Network Camera Firmware

Version: V5.5.97

Release Note (**External**)

(2019-08-06)

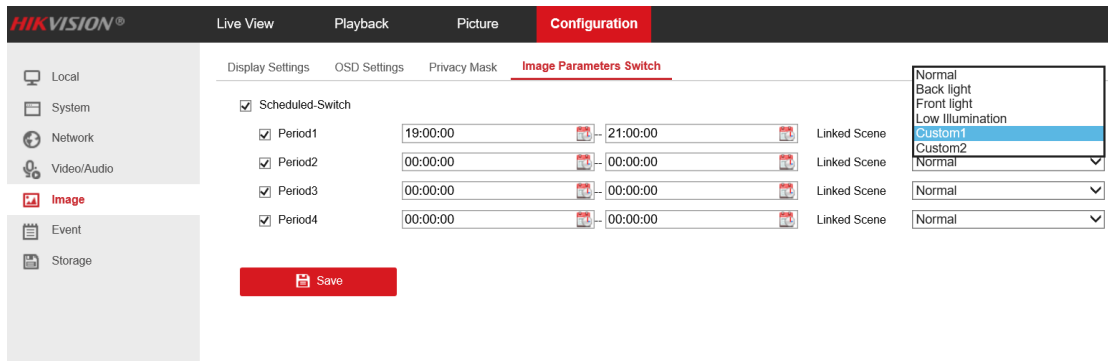
- Newly release DS-2CD2X86G2 camera.
- Support false alarm reduction.
- Support metadata.
- Support Ehome 5.0
- Support pixel counter.
- G3 device can synchronously enable smart event and motion detection.
- Live View Quick Setup: It allows quick setup of image/video related parameters on live view page.
